From: Hatala, Carlen [chatal@milwaukee.gov]
Sent: Monday, May 14, 2018 9:32 AM
To: David "Koz" Koscielniak
Subject: Porch 1921 North 2nd Street
Attachments: Crown Specialty Mouldings top rails.jpg; Porch Railings and skirting.jpg; Living With History_HPOfficeBook 50.jpg; post cap detail.jpg

Hi David,
The drawings you submitted for the front porch will not work.

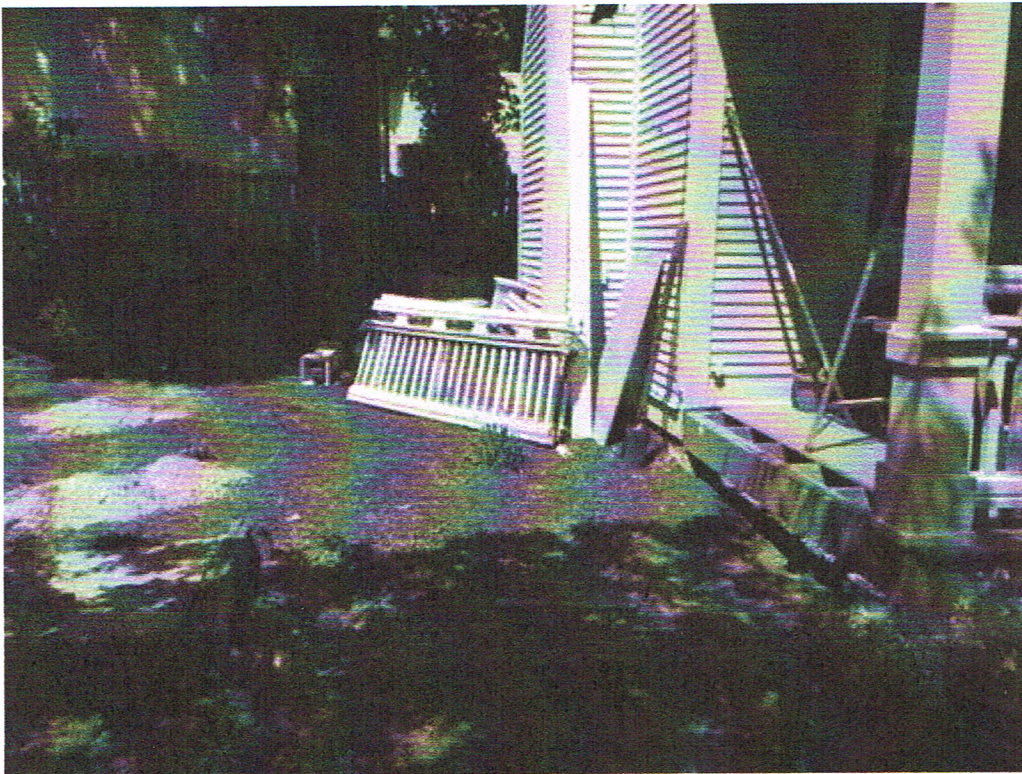
- 1) The railings are too flimsy looking—they need the handrail, bottom rail and balusters that are appropriate.
- 2) The posts look makeshift and not professional. They need a different kind of capital and base.
- 3) The posts that anchor the second story railing are too flimsy.
- 4) There can be square picket balusters but they need to be beefier and spaced closer together.
- 5) Skirting can be simple but must be framed as in attached photo.
- 6) The page from Living with History shows an appropriate porch post for an Italianate house, which this is.
- 7) Post caps on a rectangular post should have the details as shown attached. Not just a flat piece of wood nailed to the vertical post.

posts would make them substantial. This is an example in Brewers Hill

Creating a pedestal for the porch
